INFORMATION NOTE

N° 10208AERRA

Errata sheet V1.4 affecting products TC22x_AC and TC21x_AC

Device TC22x/TC21x
Marking/Step ES-AC, AC
Package see Data Sheet

Figure 1 Example sequence showing how registers ETRRx may be filled with “Error Free” addresses

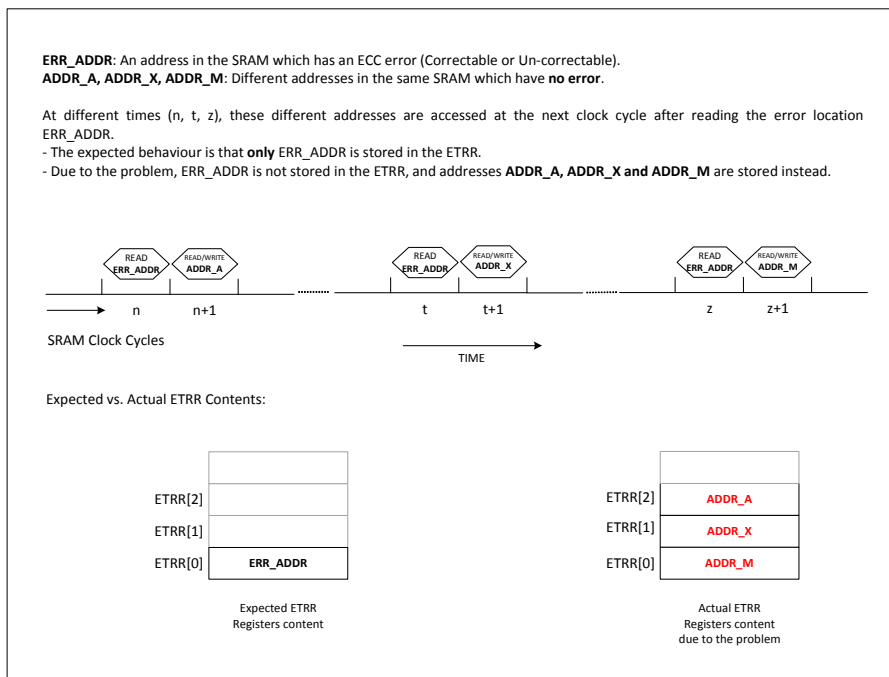
are filled with addresses that have actually no error – and the SRAM address which actually has an error is not stored indeed. **Figure 1** shows such an example scenario.

The consequence of the scenario explained in **Figure 1** is that a single error in the SRAM – example just one correctable error at a location ERR_ADDR – can result in registers ETRRx getting filled with fault-free address, and thus potentially even triggering an ETRR overflow.

2. Depending on the access sequences, an ETRR overflow might be triggered with one real error (e.g. correctable error) in the SRAM – consequence of the example shown in [Figure 1](#).

Figure 2 Recommended Software Handling - Flowchart

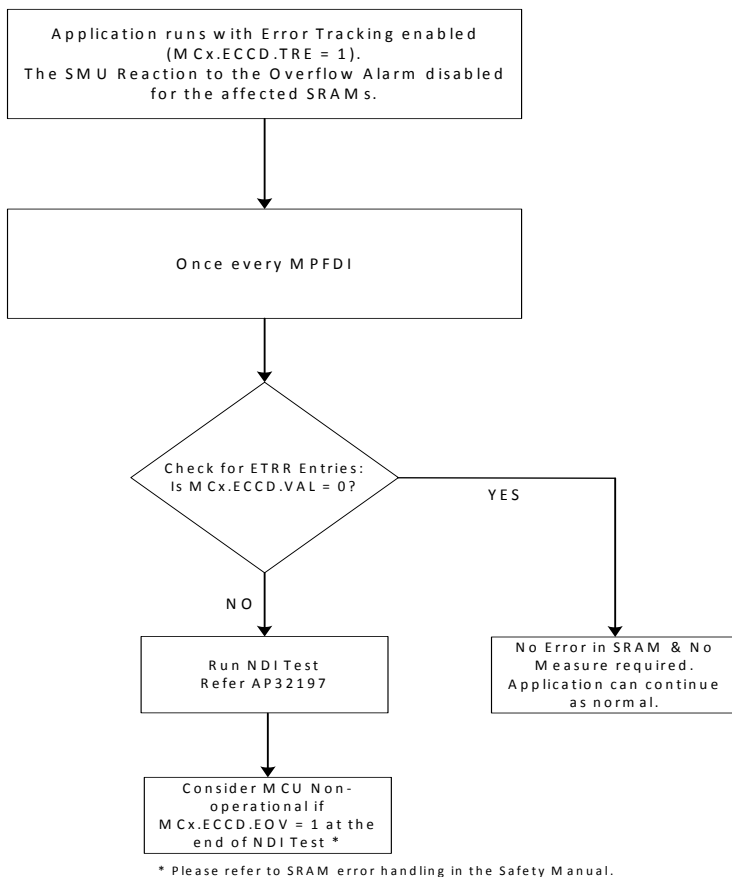
A flowchart of the recommended software handling is shown in [Figure 2](#).

If there is at least one valid ETRR entry (i.e. $MCx.ECCD.VAL \neq 0$) then the software shall run a Non-Destructive-Inversion (NDI) Test on the affected SRAM. Please refer to application note AP32197 (AURIX™ Memory tests using the MTU) for an example regarding running this test.

At the end of this test, if an ETRR overflow is detected ($MCx.ECCD.EOV = 1_B$) then the MCU shall be considered non-operational. Refer to section on Correctable SRAM Error handling in the Safety Manual.

Figure 9 Short Serial Message, Serial Data Encoding over 16 messages

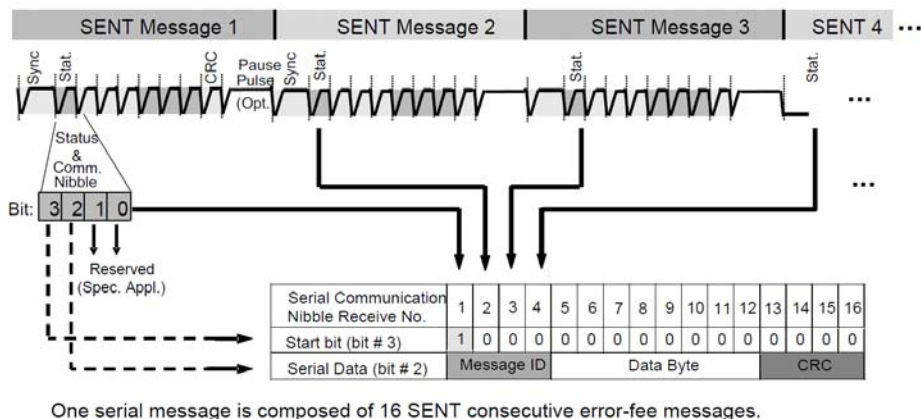
Correction

Figure 9 shows a corrected version of this figure.
